# Access Compliance Report
Public Rights-of-Way
(Curb Ramps)

Intersection ID: 28180	Main Street: AUTUMN_APPLAUSE_DR	Cross Street: HUNTLAND_CT	Location:	NW
ADA ID: 50DECEED6CF6	Ramp Type: PerpDiag	Initial Pass/Fail: Fail	Overall Compliance: No	Severity Score: 36.25

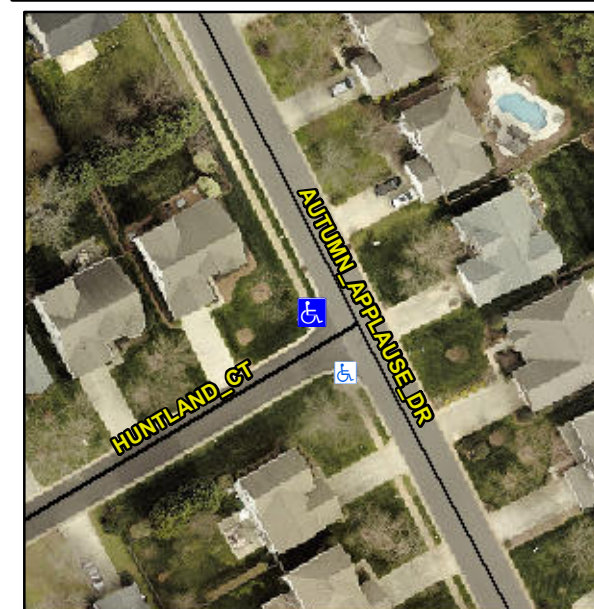
Not Found, R304.5.1, R304.5.3

Compliance	Description	Data	Compliance	Description	Data
N/A	Ramp Length (in)	96.0	Yes	Ramp Slope (%)	5.6
No	Ramp Width (in)	25.0	No	Ramp XSlope (%)	3.6
N/A	Flare Type LT	N/A	N/A	Flare Type RT	N/A
N/A	Flare Slope LT (%)	N/A	N/A	Flare Slope RT (%)	N/A
N/A	Flare Traversable LT?	N/A	N/A	Flare Traversable RT?	N/A
N/A	Landing Length (in)	N/A	N/A	DWS Provided?	N/A
N/A	Landing Width (in)	N/A	N/A	DWS Contrast?	N/A
N/A	Landing Slope (%)	N/A	N/A	DWS Length (in)	N/A
N/A	Landing X Slope (%)	N/A	N/A	DWS Full Width?	N/A
N/A	Landing Curb? (Y/N)	N/A	N/A	DWS Offset (in)	N/A
N/A	Shared Landing?	N/A			
N/A	Gutter Ponding?	N/A	N/A	Gutter Slope (%)	N/A
N/A	Gutter Lip Ht (in)	N/A	N/A	Gutter X Slope (%)	N/A
N/A	Painted X Walk1?	No	N/A	Painted X Walk2?	No
	X Walk 1 Direction	To SE		X Walk 2 Direction	To NE
N/A	X Walk 1 Width (in)	N/A	N/A	X Walk 2 Width (in)	N/A
	X Walk 1 Slope (%)	0.7		X Walk 2 Slope (%)	4.5
	X Walk 1 X Slope (%)	4.0		X Walk 2 X Slope (%)	0.4

Remove & Replace Curb Ramp With Two New Directional Ramps or Equivalent.
